ADDENDUM NO. 2

DUBLIN-JEROME HIGH SCHOOL – WEIGHT ROOM RENOVATION

Project No. 225079.00

January 15, 2026

FIRE ALARM PLAN

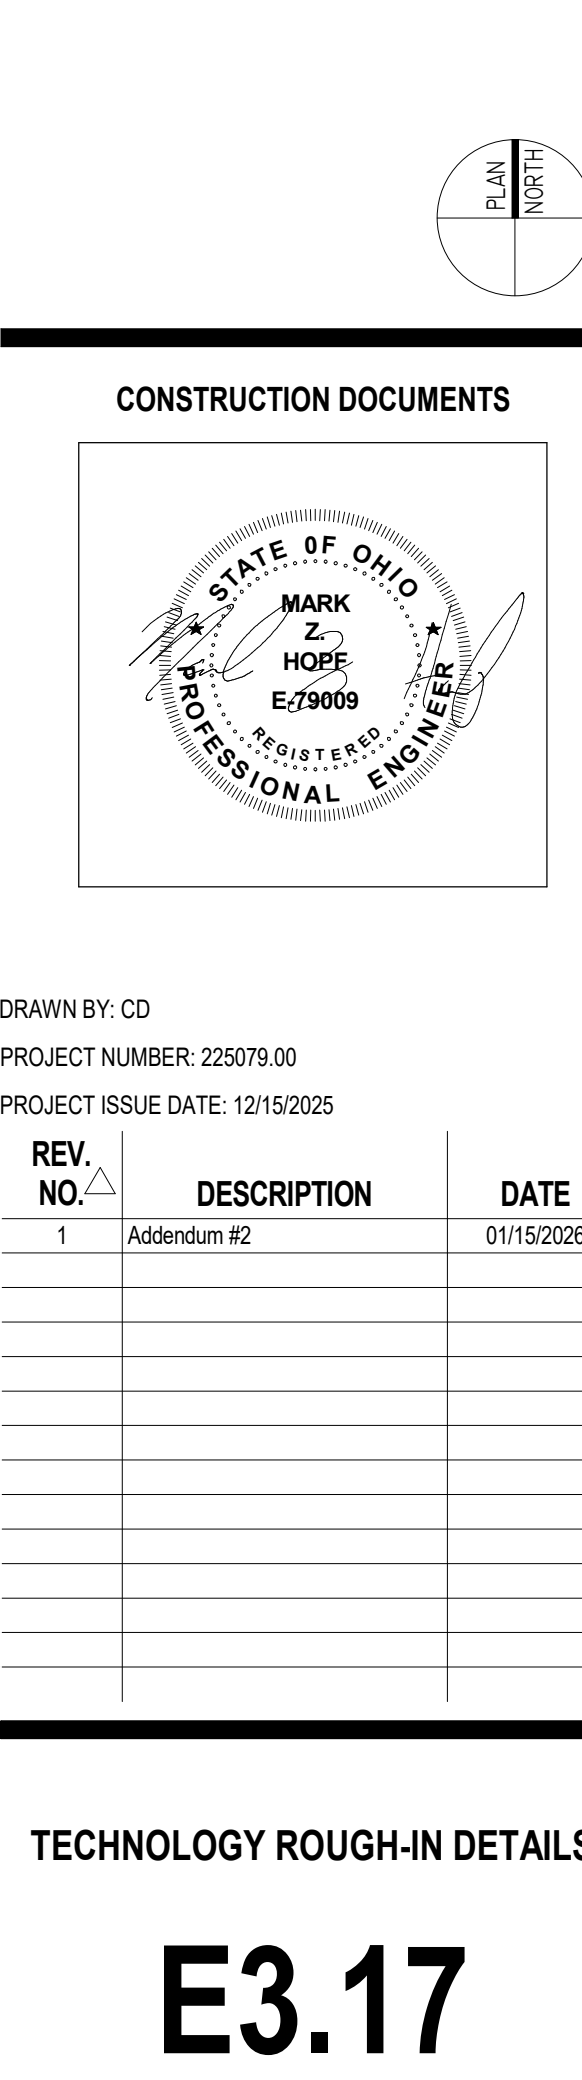
- A. Drawing Sheet Nos. E3-17 and E6-01 have been revised, and dated 1-15-26, and are included with and hereby made part of this Addendum. These Drawings supersede the original documents.
